STAIR SECTION

TAUBE FAMILY CARRIAGE HOUSE ADDITION
San Mateo County History Museum

San Mateo County Historical Association
22200 Broadway Redwood City, CA 94063
APN: 052-367-010

A4.5

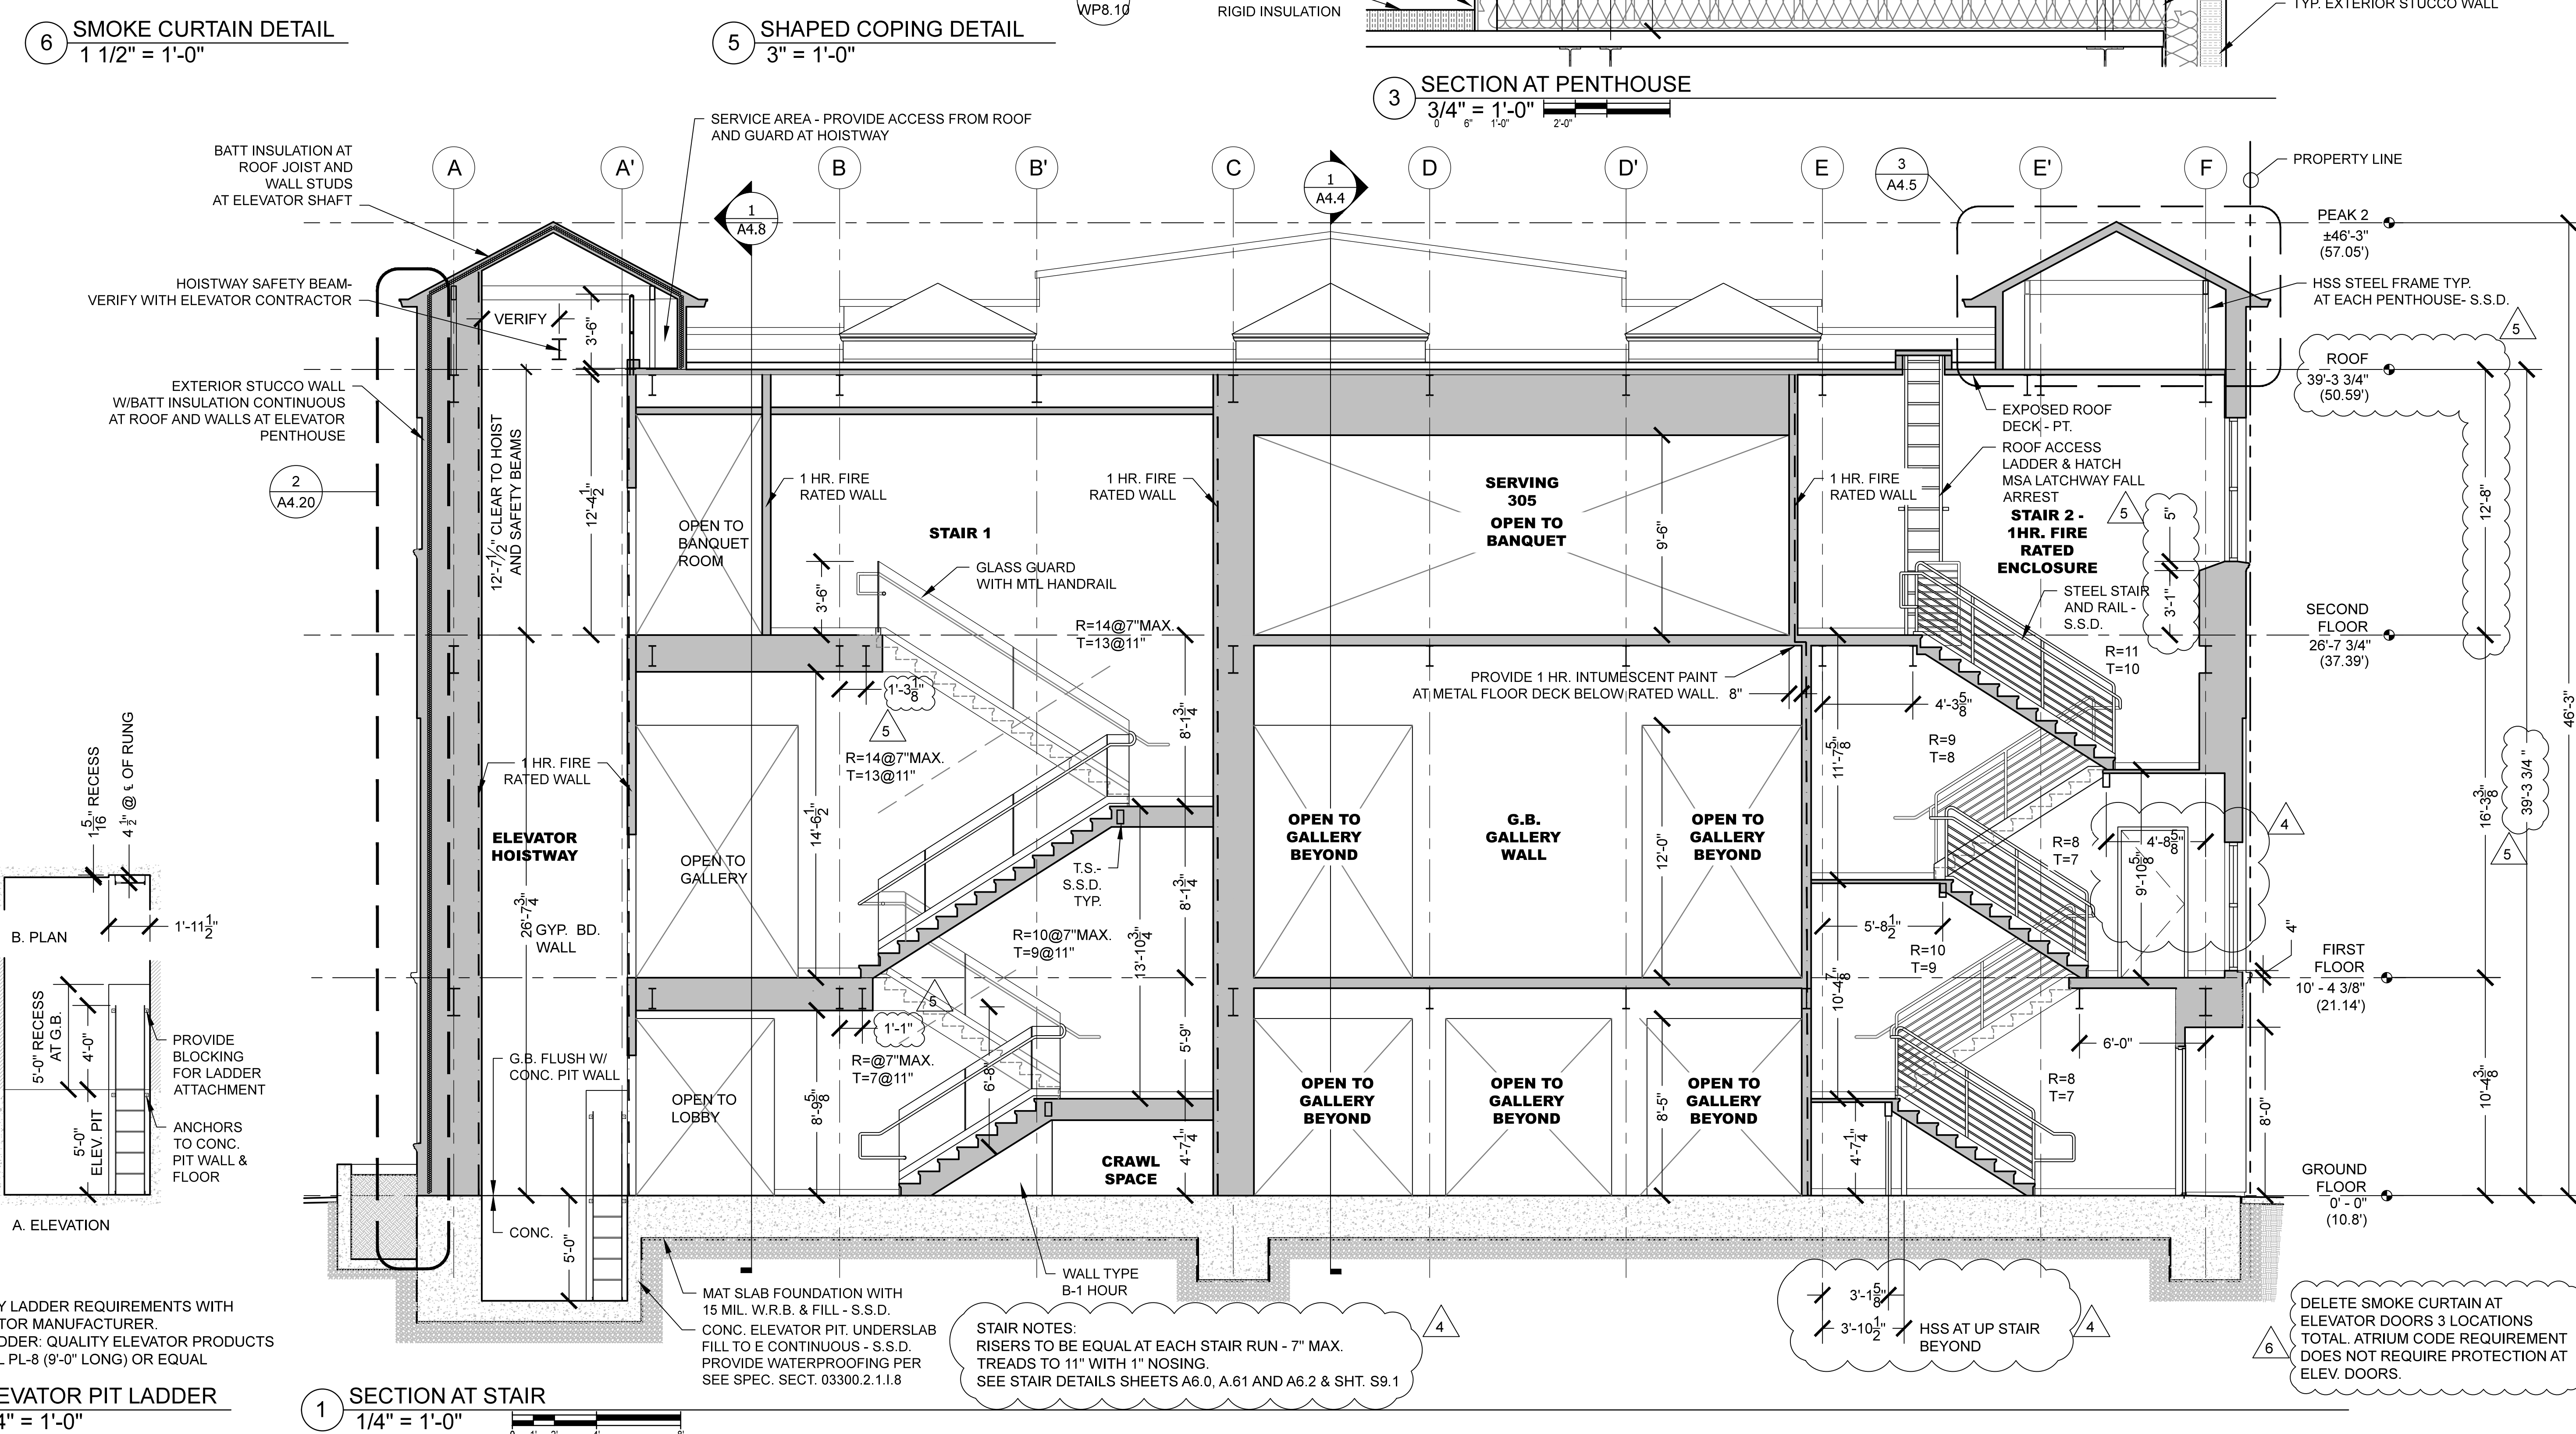
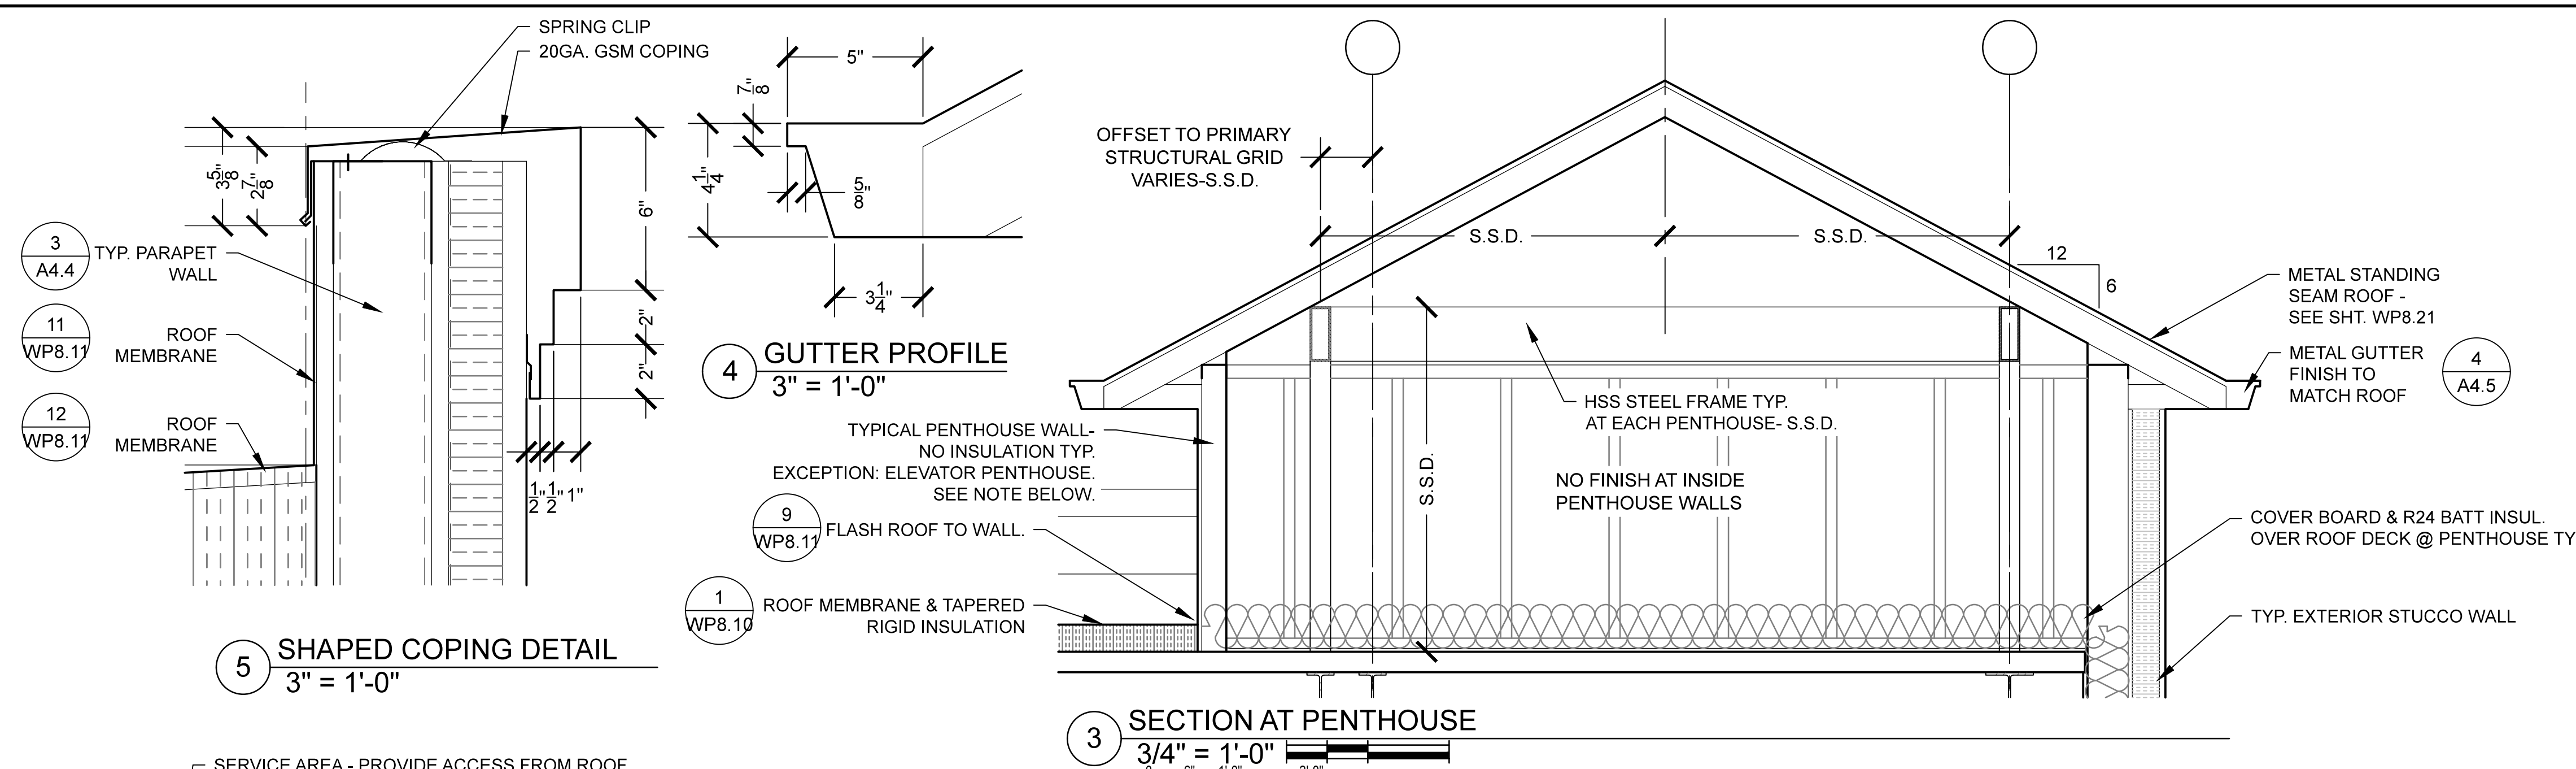
DELETE SMOKE CURTAIN AT
ELEVATOR DOORS 3 LOCATIONS
TOTAL. ATRIUM CODE REQUIREMENT
DOES NOT REQUIRE PROTECTION AT
ELEV. DOORS.
